Proposals for UN/FLUX standard XSD updates

European Commission, DG MARE
Maris.Berzins@ec.europa.eu

Second Session of the Team of Specialists on Sustainable Fisheries
Geneva, 31 January – 1 February 2019

Changes in FLAP domain

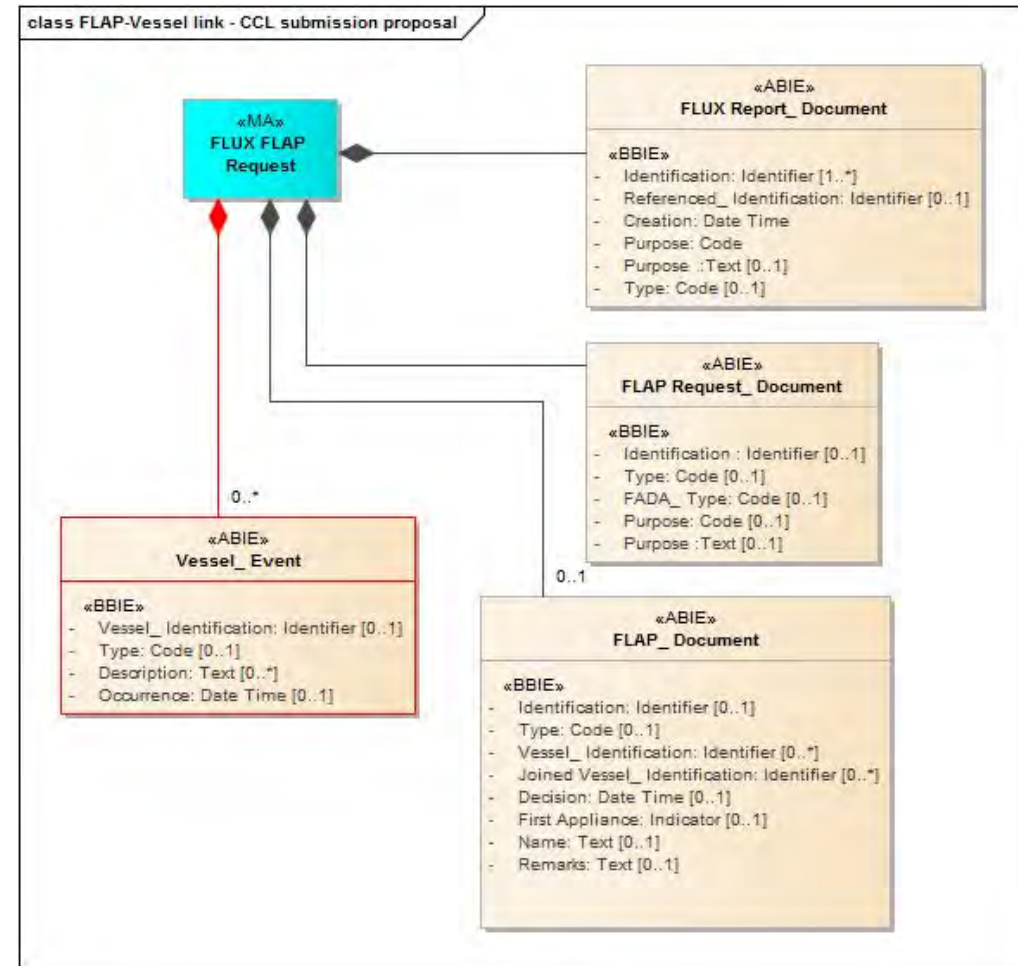
- Proposed change
 - link 'Vessel_Event' entity (and all sublinked entities) to 'FLUX FLAP Request' message
- Reason
 - most flexible solution to submit the FLAP request together with full list of vessel details

Changes in Vessel domain

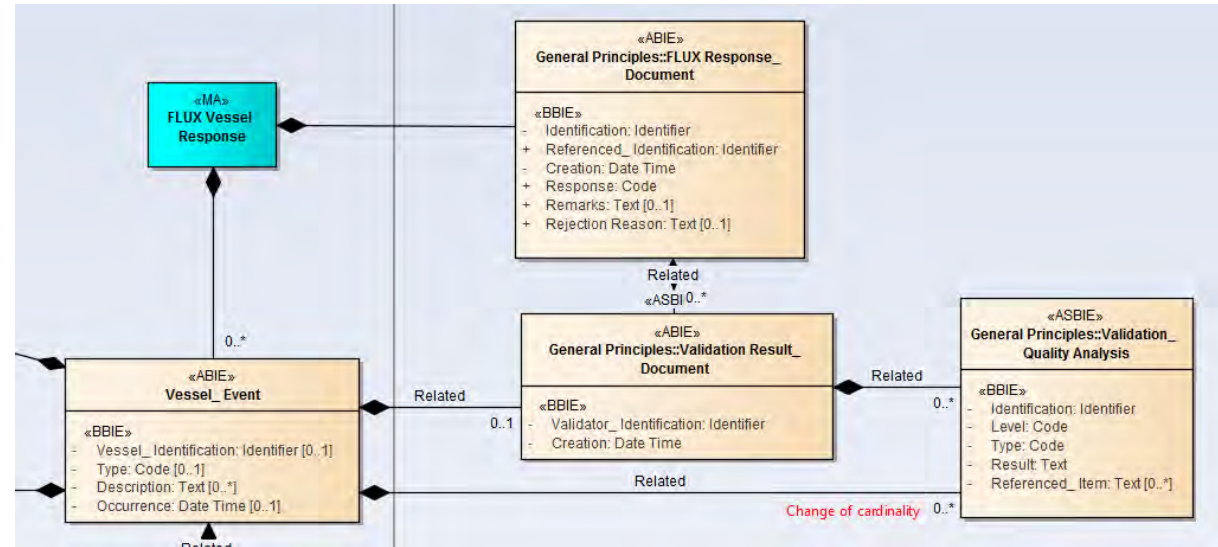
- Proposed change

- change cardinality for 'Vessel Event' link with 'Validation Quality Analysis' entity

- Reason

- better reporting of multiple validation results of one vessel event
- avoid repetition of 'Validator Result Document' entity

Changes in Vessel domain

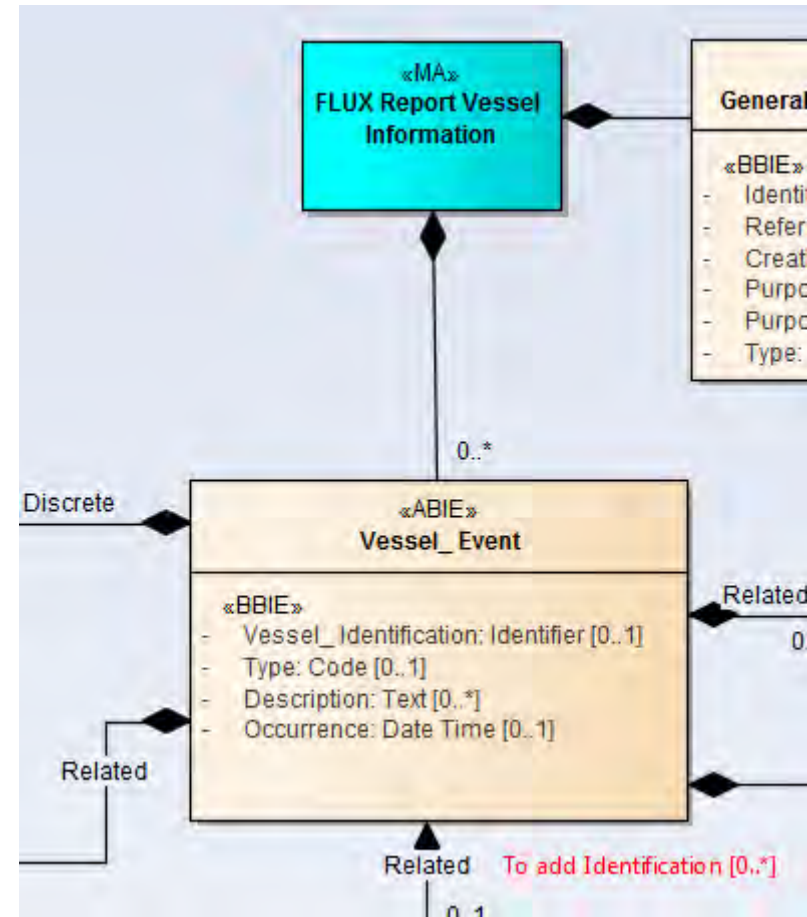
- Proposed change
 - Add 'Identification: Identifier' data element in 'Vessel Event' entity
- Reason
 - easier identification of data set received and compare with data received earlier (i.e. for sending updates)
 - It can be an identifier (automatically encrypted key) for data combination reported in that message

Changes in Sales domain

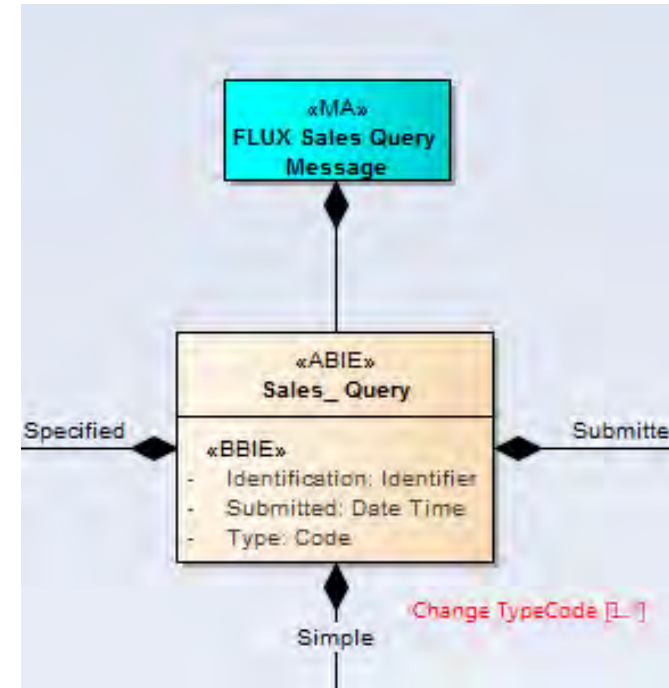
- Proposed change
 - Change cardinality to (1..*) of 'Type: Code' data element in 'Sales Query' entity
- Reason
 - Several query types (SN, TOD) exist today. The solution allows to query all of them in one request

Changes in MDR domain

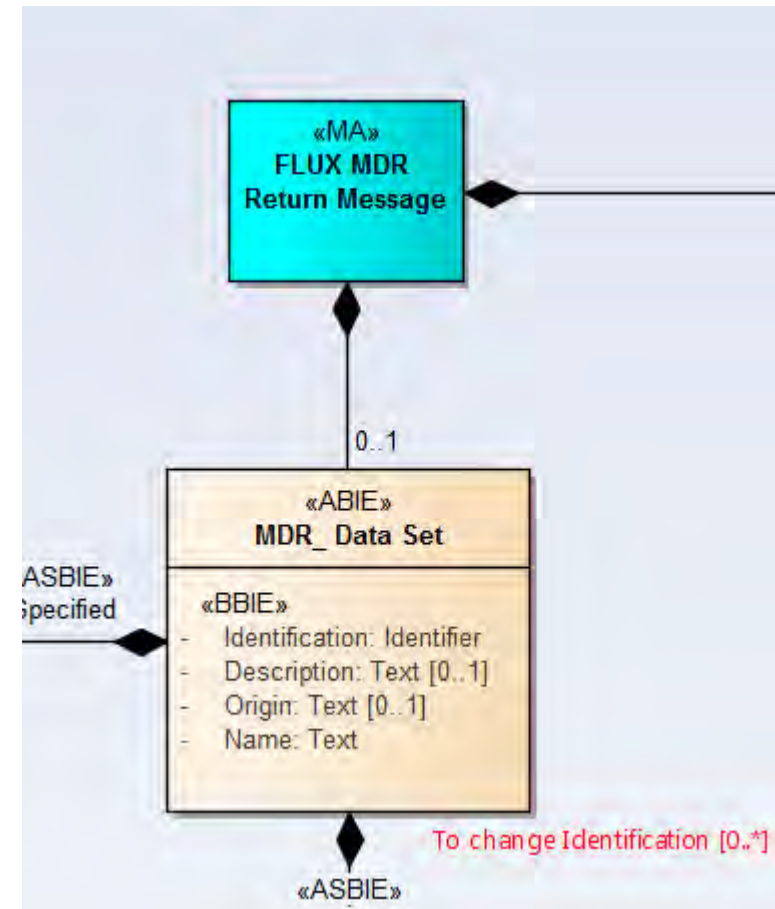
- Proposed change
 - Change cardinality to (1..*) of 'Identification: Identifier' data element in 'MDR Data set' entity
- Reason
 - A code list can have multiple identifiers
